**STAFF RECOMMENDATION**  
**2121 Blair Boulevard**  
**September 19, 2018**

**Application:** New Construction - Addition; Setback Determination  
**District:** Hillsboro-West End Neighborhood Conservation Zoning Overlay  
**Council District:** 18  
**Map and Parcel Number:** 10415017700  
**Applicant:** Candis Carroll  
**Project Lead:** Sean Alexander, sean.alexander@nashville.gov

SITE PLAN

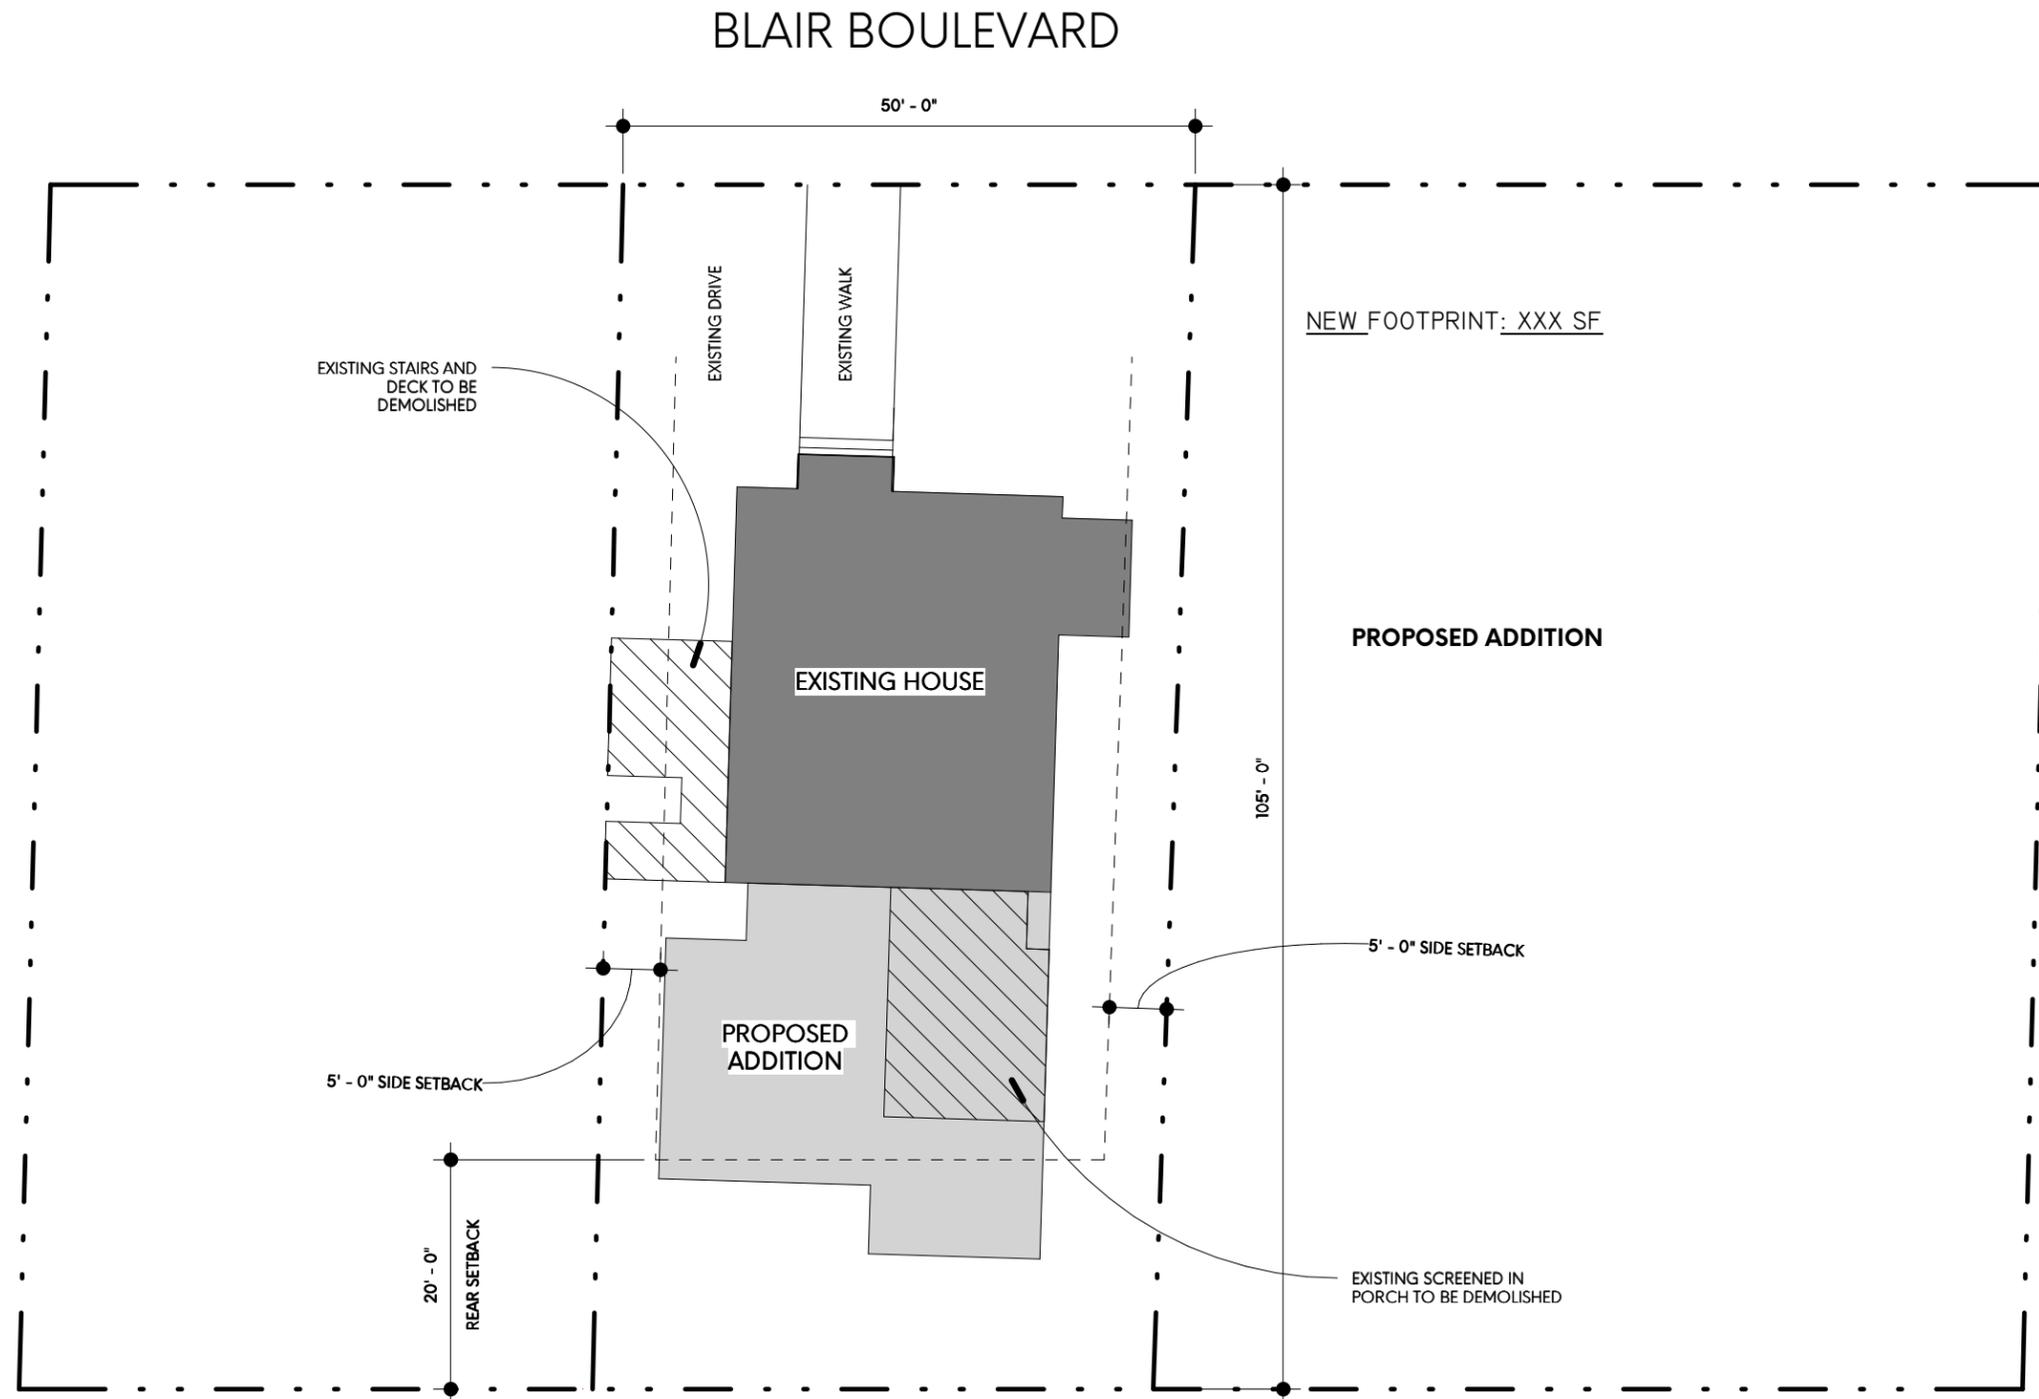
Setback & Rhythm of Spacing: The addition will meet the required five foot (5') side setbacks, and even with the additional width on the right side the project will be compatible with the rhythm of spacing between existing buildings.

The applicant is requesting a ten foot (10') rear setback for the addition. Although the depth of the addition is not unusual, the proposed addition would not meet the standard twenty-foot (20') rear setback requirement because the lot at 2121 Blair Boulevard is shallower than typical lots nearby at only one hundred, five feet (105') deep.

Staff finds that the setbacks of the project are appropriate and that it meets section II.B.1.c of the design guidelines.

FLOOR PLANS

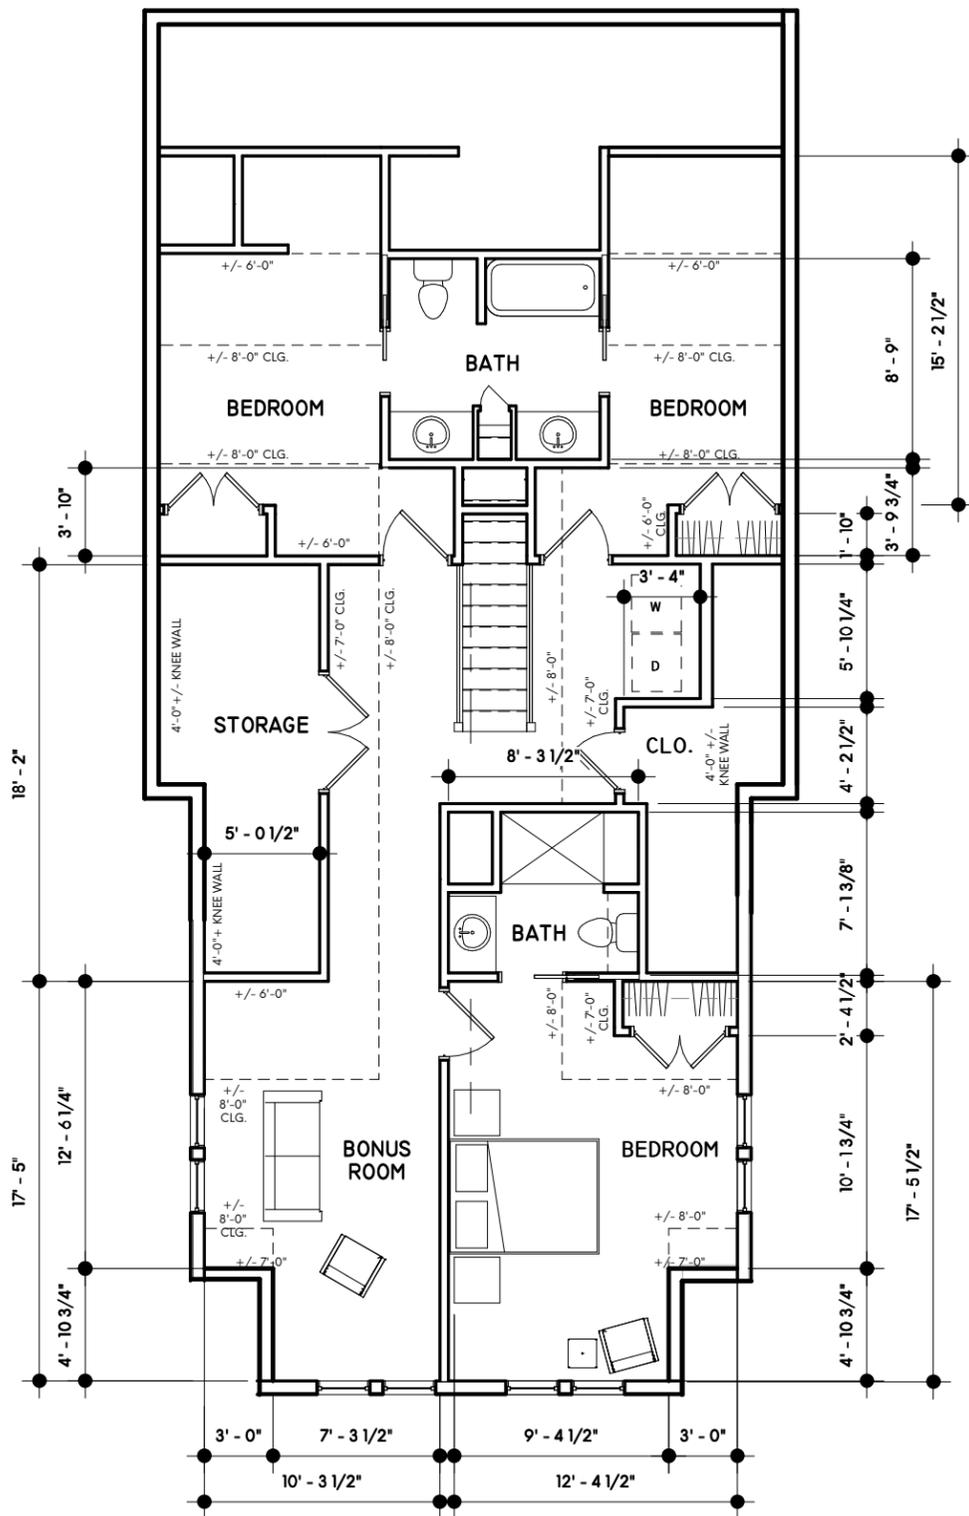
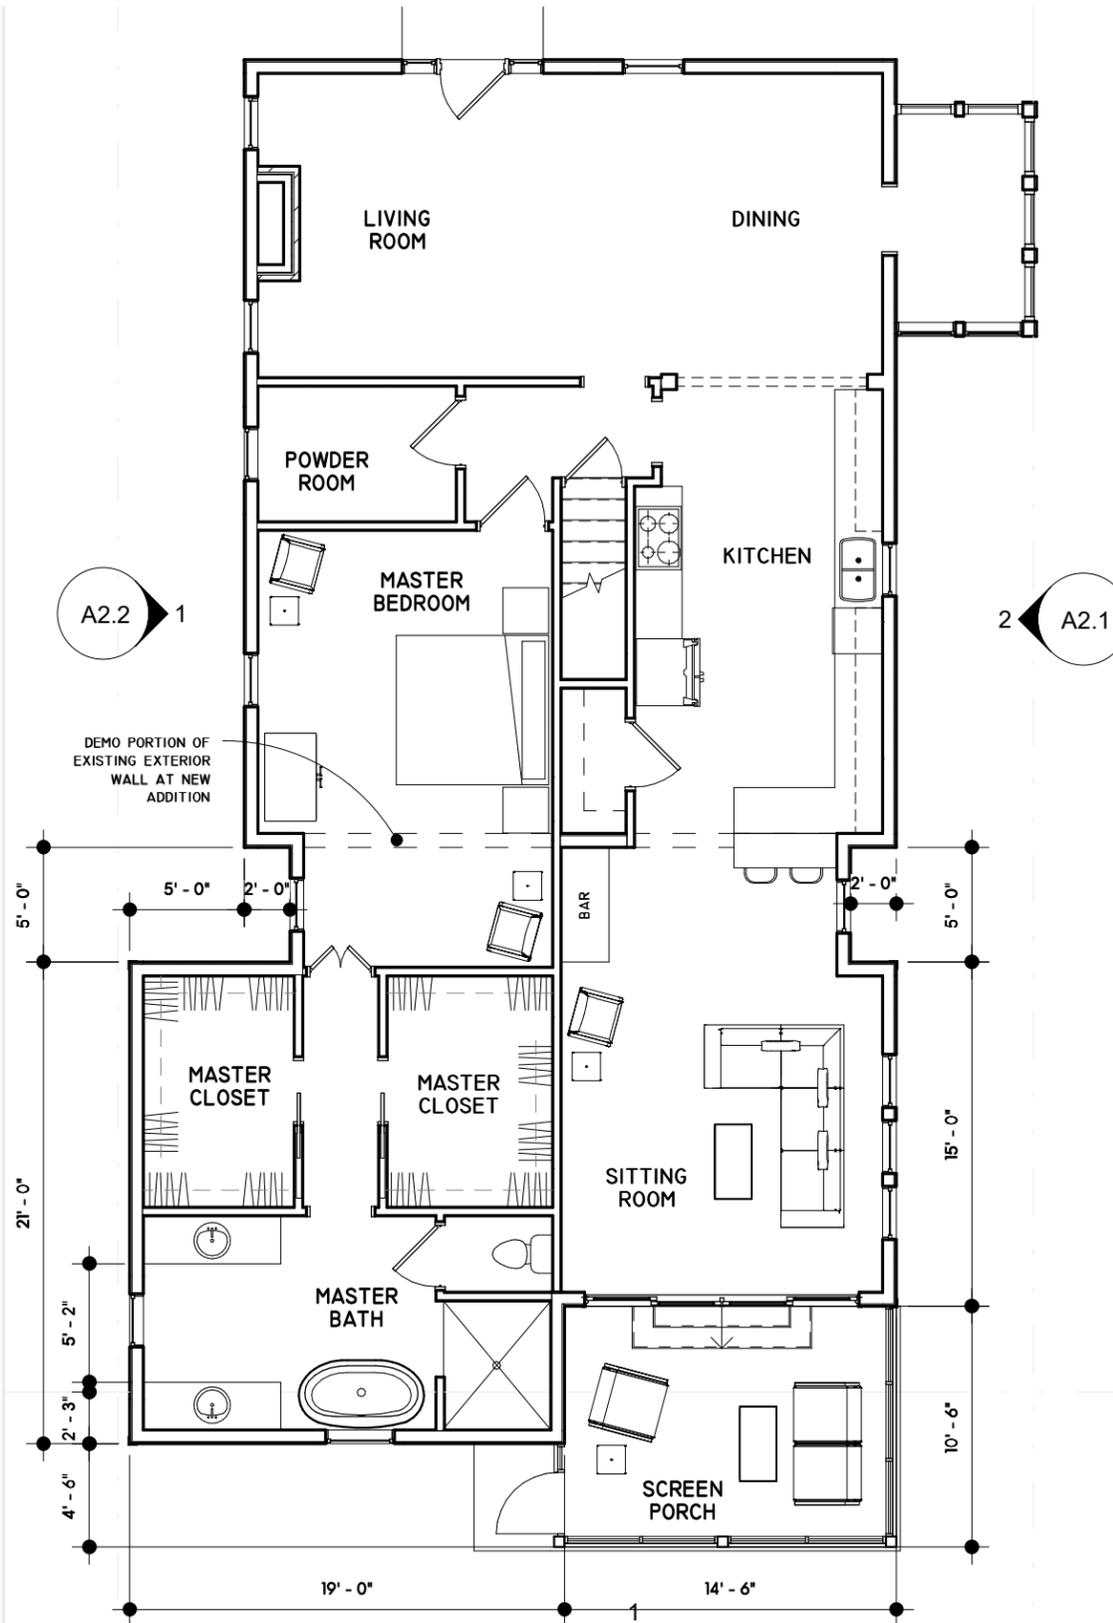
Location & Removability: The new addition will have a two story mass that begins behind the rear wall of the historic house, stepped in two feet (2') from the primary walls of the house on both sides, with sections of the first story stepping back out on both sides.

Height & Scale: The sides of the addition will step in two feet (2') from the sides of the house and extend back thirty-one feet (31'). The upperstory walls will remain stepped in two feet (2') but after extending back five feet (5'), the first story of the addition will step back out two feet (2') to the left to align with the house's primary side wall and the right side will step out seven feet (7') to the right. The wider portion will be a single story, beginning thirty-nine feet (39') back from the front of the house, stepping five feet (5') wider than the historic house and going back a depth of twenty-one feet (21'). In general, additions should not be wider than historic houses except when the house is narrower than thirty feet (30') wide, shifted on the lot, or the lot is greater than fifty feet (50')

Utilities: The plans do not indicate the HVAC units or utilities being relocated. If they are to be relocated, Staff asks they are located behind the midpoint of the building or on the rear in order to meet section II.B.1.i of the design guidelines.

1. The window and door selections, are approved administratively prior to construction; and,
2. The HVAC units and utilities are behind the midpoint or on the rear of the building.
